EBEY'S LANDING HISTORIC PRESERVATION COMMISSION
ISLAND COUNTY COMMISSIONERS' HEARING ROOM (Room 102B)
1 NE 6th St., COUPEVILLE, WA
AUGUST 28, 2025

Ebey's Landing National Historical Reserve
Certificate of Appropriateness
Connor Tasoff
304 NE Fifth St
COA-25-028

Ebey's Landing National Historical Reserve
Certificate of Appropriateness
Wood
433 Wanamaker Road, Coupeville
EBY-25-023

AFTER-THE-FACT REMODEL; CONDITIONS OF APPROVAL UPDATE

South Elevation
Per Property Clean Up

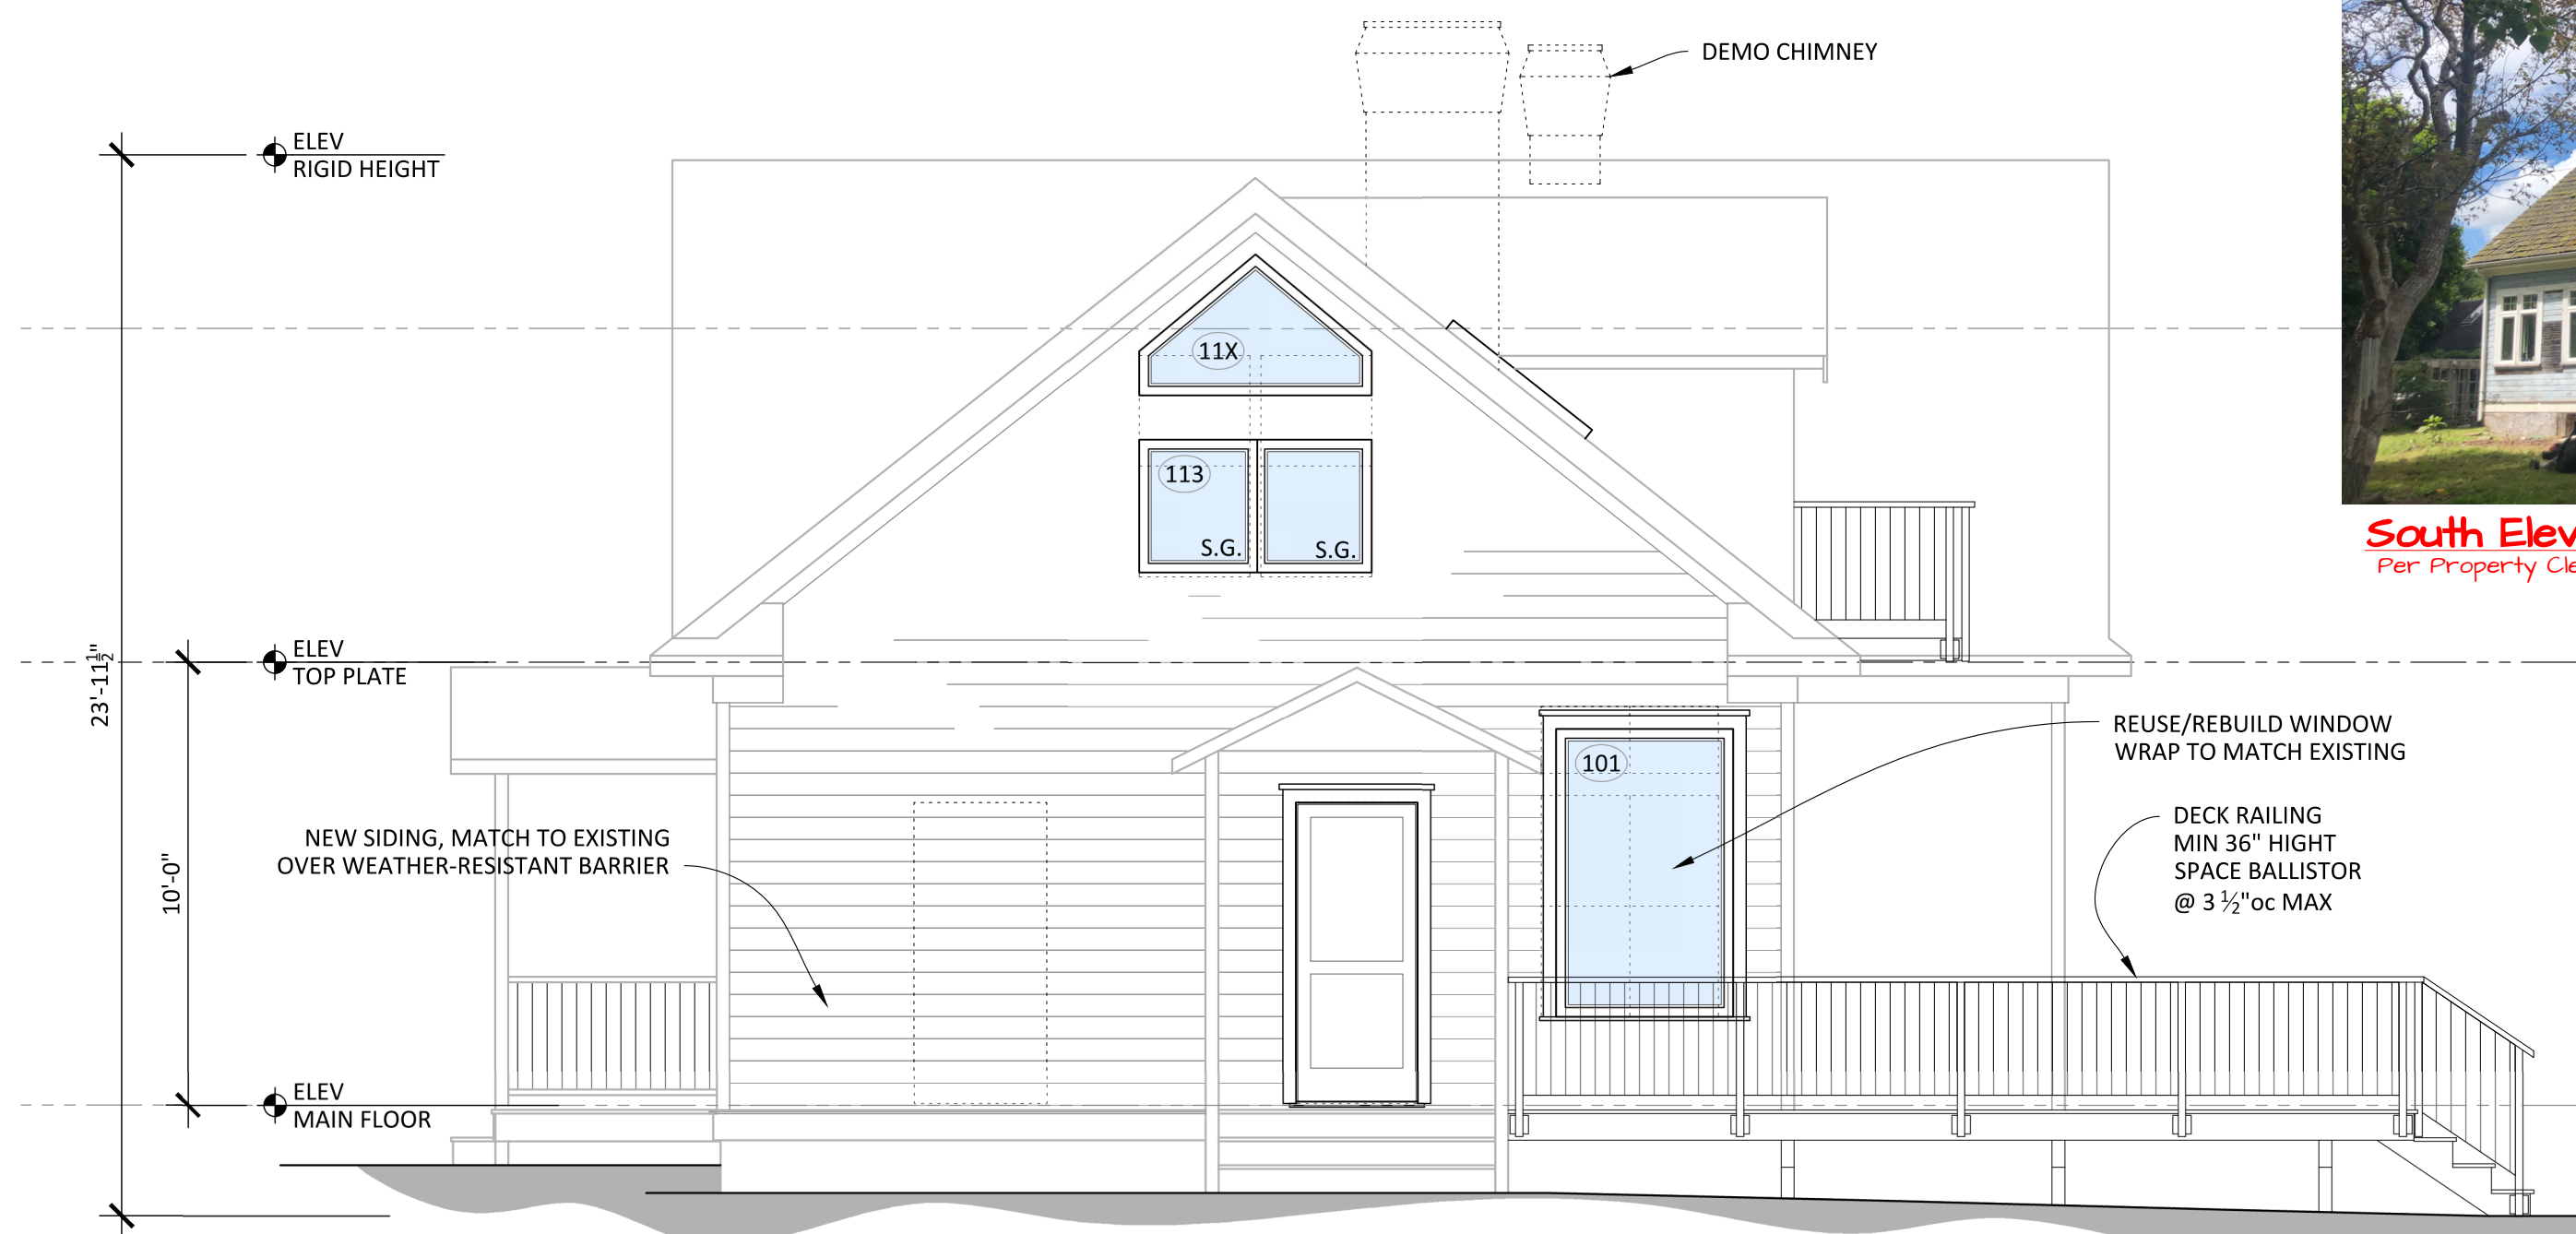
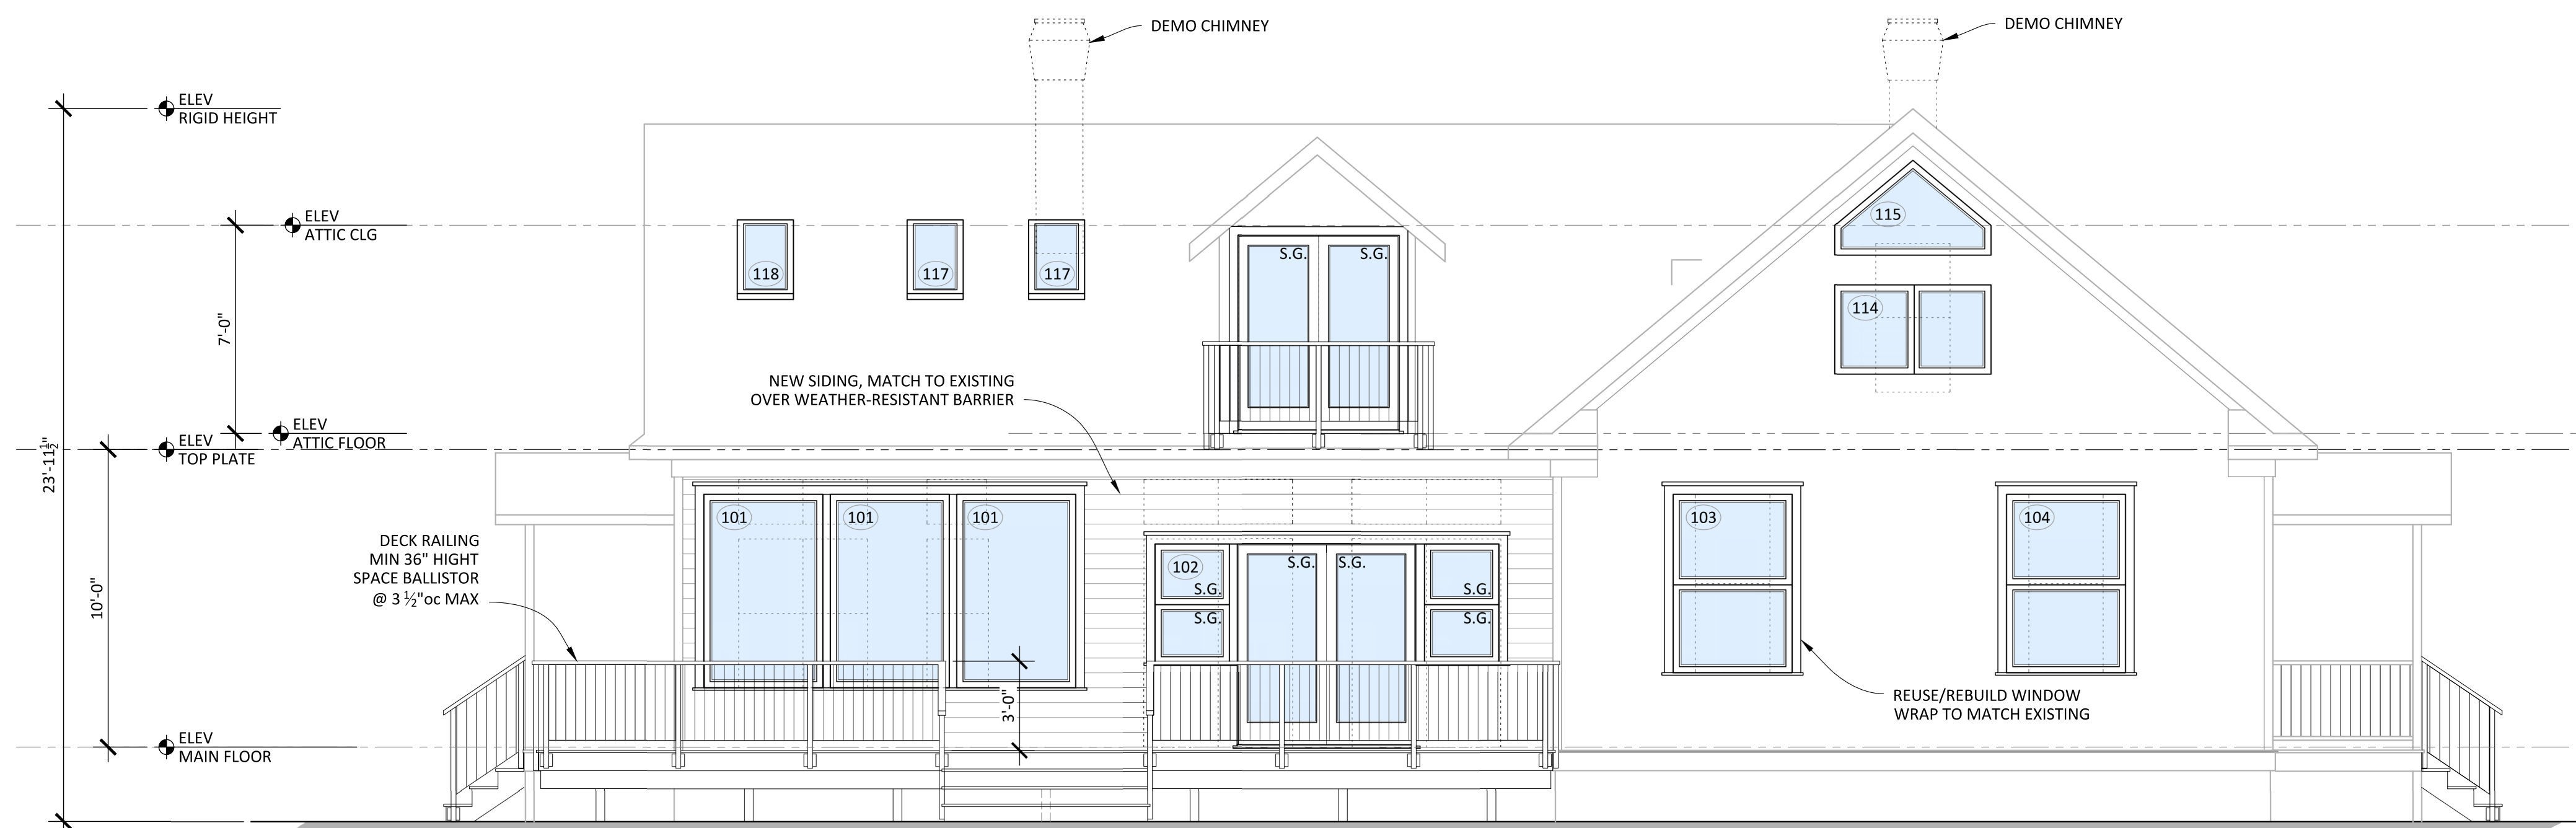
1. The bellyband on the eastern and western façade must be removed.
2. The windows of the eastern façade must be restored to its original dimensions.
3. Reinstall the previous doors of the eastern façade or reframe the opening by removing the sidelight.

On August 14, 2025, the applicant provided updated elevation plans that satisfy the conditions of approval approved by the Historic Preservation Commission.
